June 14, 2010  
In reply refer to SHEA-110063

Subject: Response to RWQCB and DTSC comments on the 2010 Interim Source Removal Action (ISRA) Work Plan Addendum Submitted in Response to California Water Code Section 13304 Order (NPDES NO. CA0001309, CI NO. 6027, SCP NO. 1111, SITE ID NO. 2040109)

SUBJECT: Response to RWQCB and DTSC Comments on the 2010 ISRA Work Plan  
Addendum

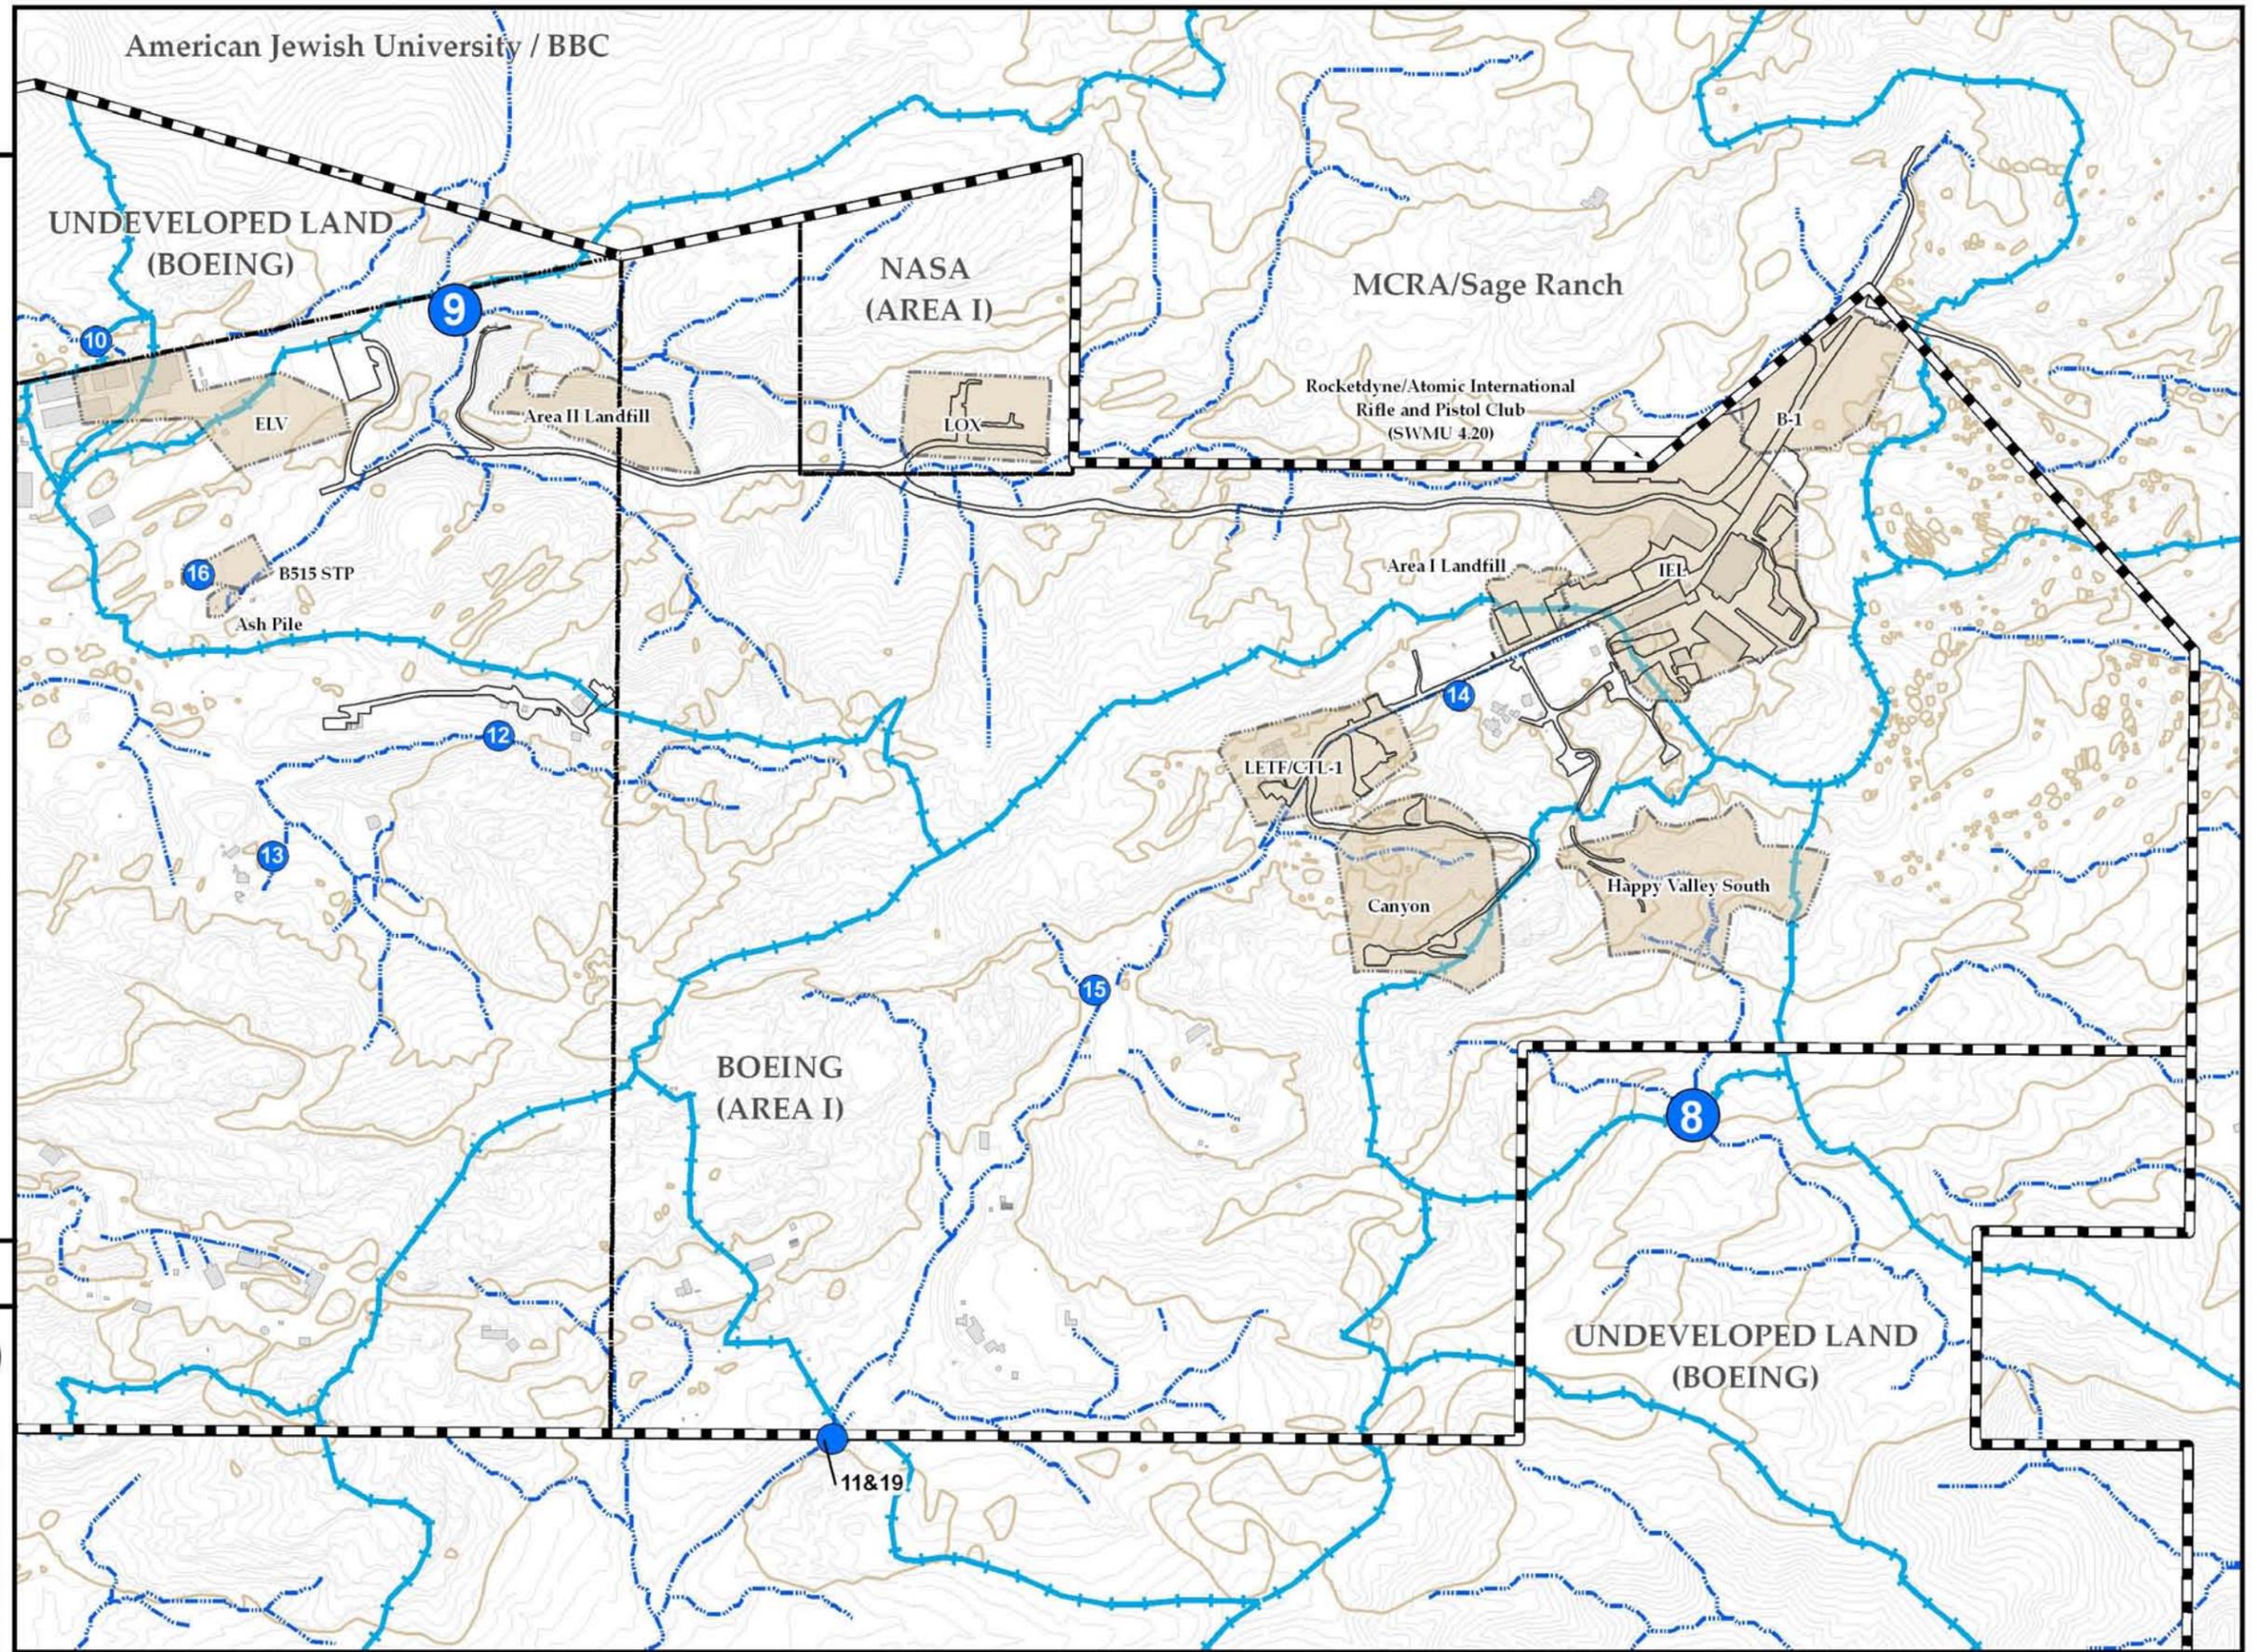
**Comment #9:** Include a summary of each former operational site (RFI Site) which is collocated with or located near a 2010 ISRA Area.

**Response:** A summary of available information on the RFI Sites associated with ISRA Areas recommended for action in the Work Plan Addendum, including the B-1 Area, the Instrument and Equipment Laboratories (IEL), the Area I Landfill (A1LF), the Component Testing Laboratory I (CTL-I), the former LOX Plant, the Area II Landfill (A2LF), and the Incinerator Ash Pile/Sewage Treatment Plant (AP/STP) Area have been compiled and are included in the errata package attached to this memorandum as a new appendix (Appendix C) to the Work Plan Addendum. In addition, Figure 1-2 has been revised to show the location of CTL-I.

Figure 1-2 has been revised to show the location of CTL-I.

Figure 2-14 (Revised)  
Refined Preliminary ISRA Evaluation Areas  
LOX-1 PEA, Outfall 009  
Santa Susana Field Laboratory

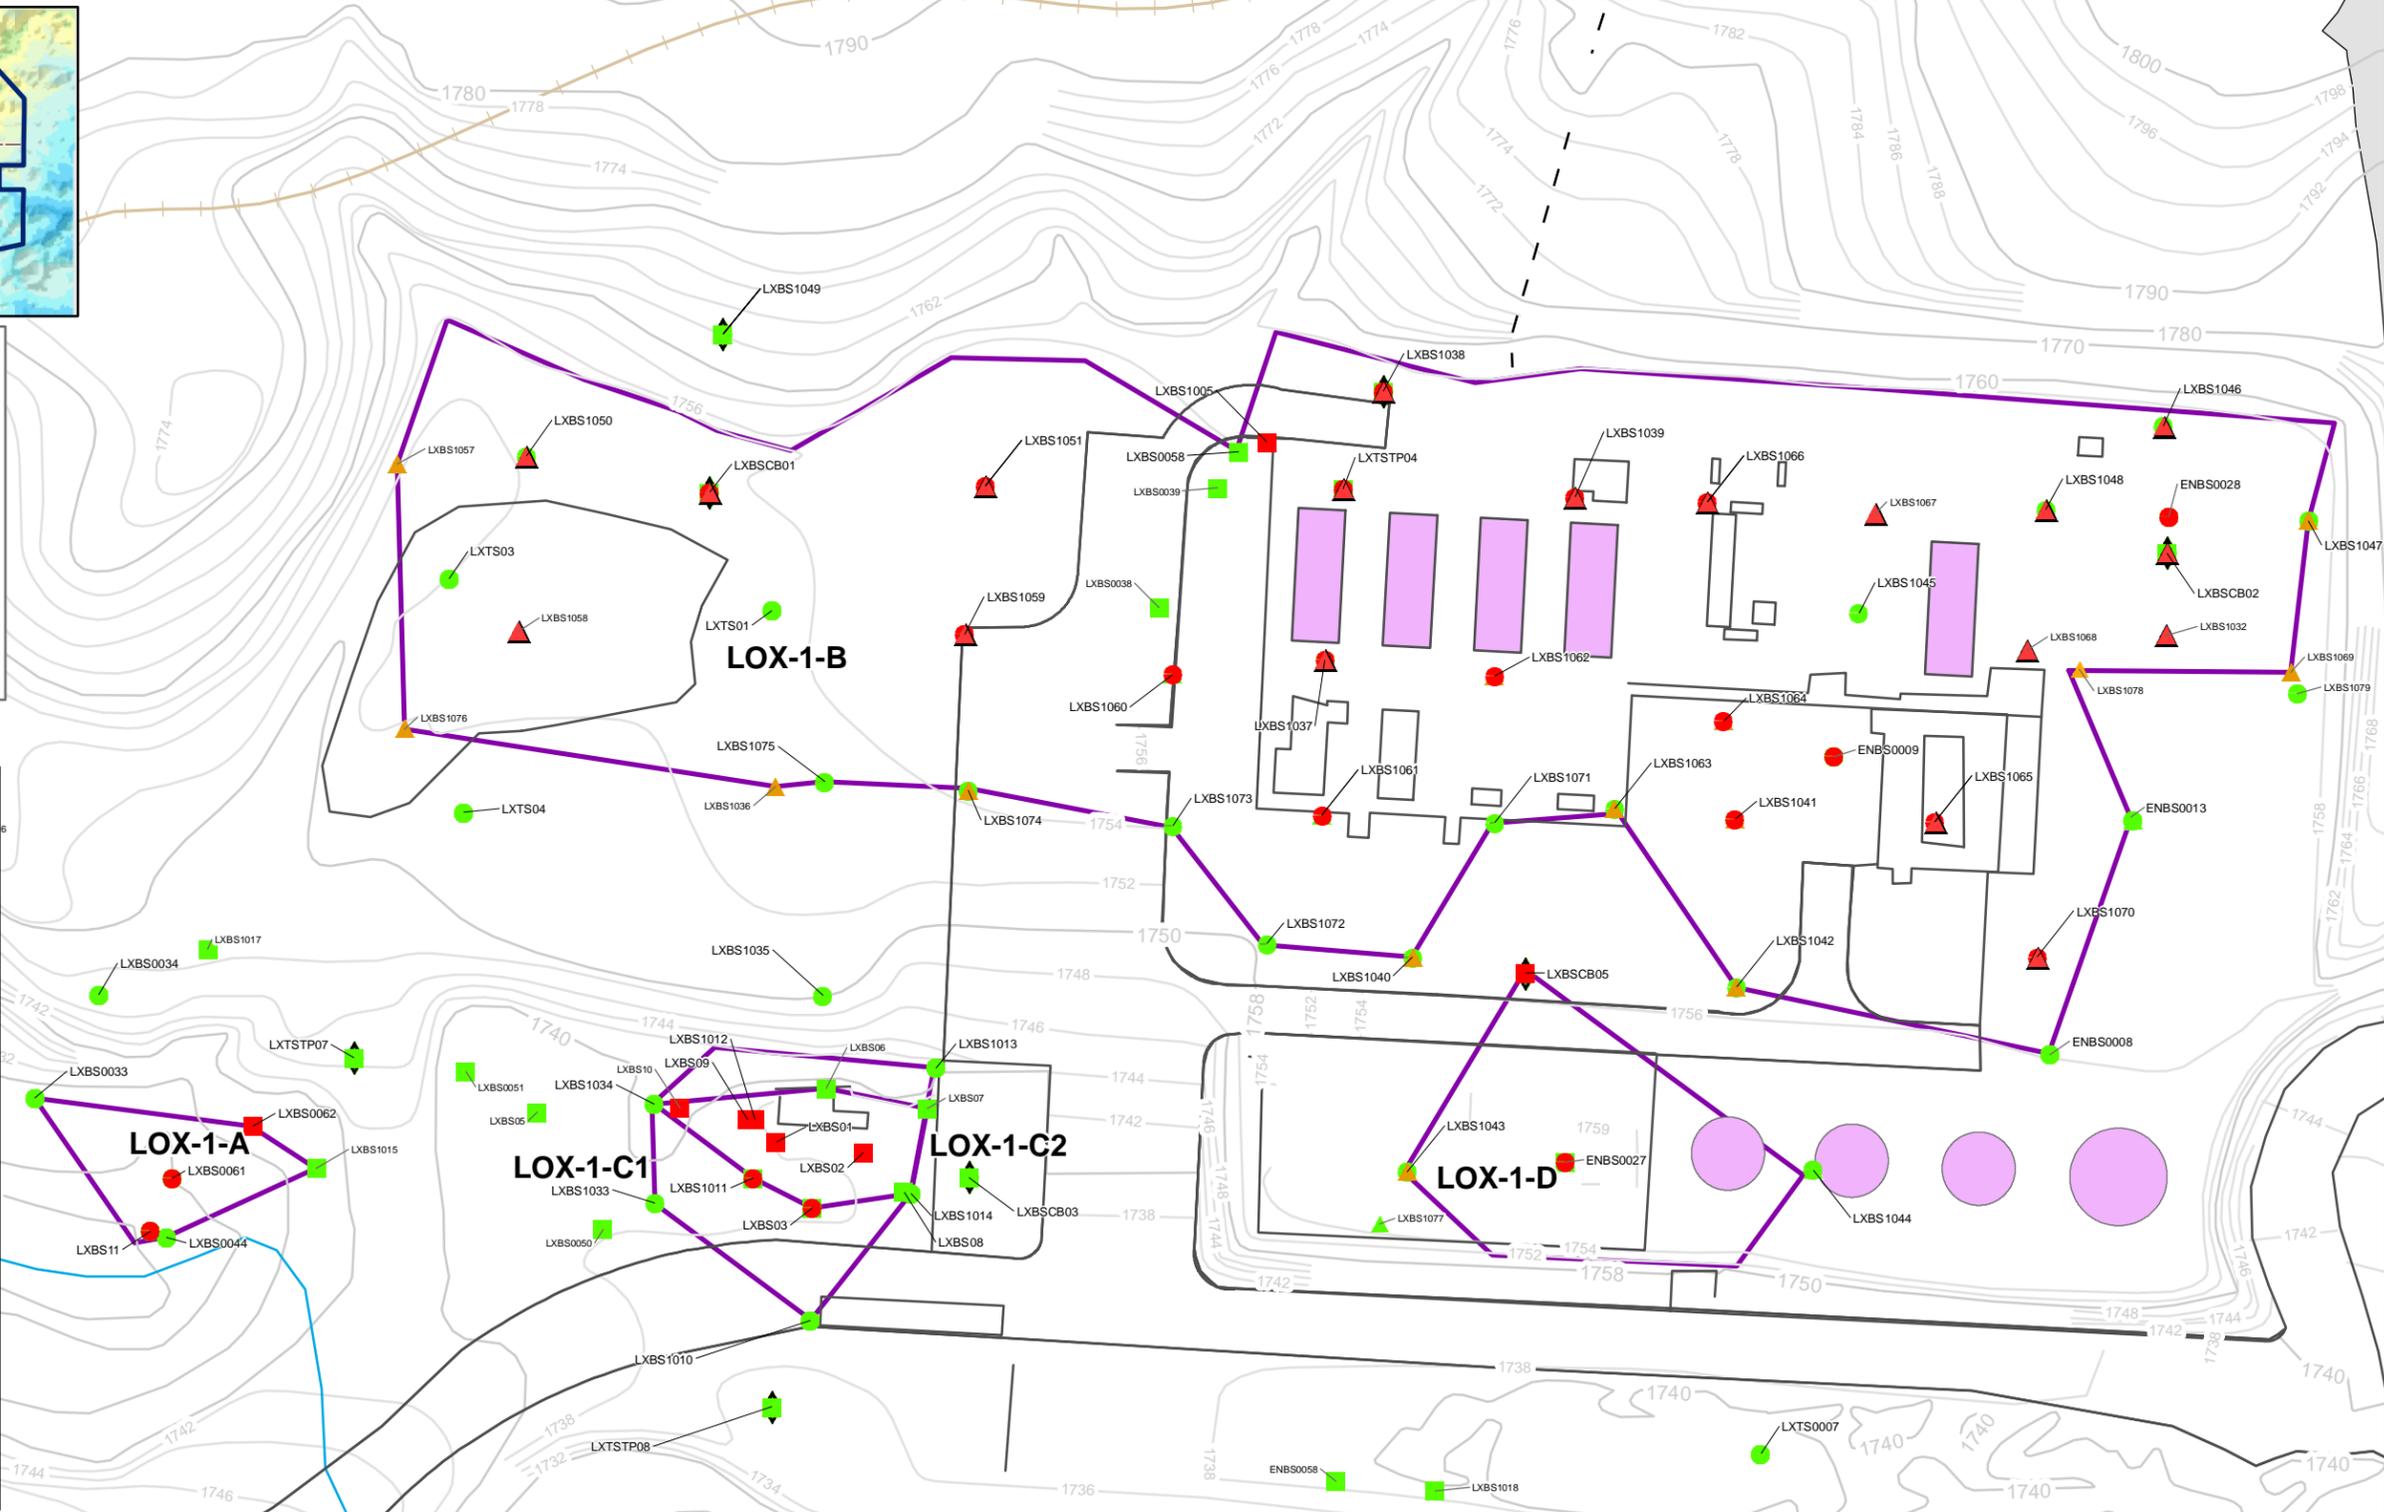
**Comment #5:** Work Plan Figure 2-14 (Refined Preliminary ISRA Evaluation Areas Outfall 009 - LOX-1) represents dioxin data with black triangles, but black triangles are not identified in the legend.

**Response:** The black triangles on Figure 2-14 should have been yellow. Figure 2-14 has been revised and is included in the errata package attached to this memorandum.

Figure 2-14 was revised to replace the black triangles with yellow triangles.
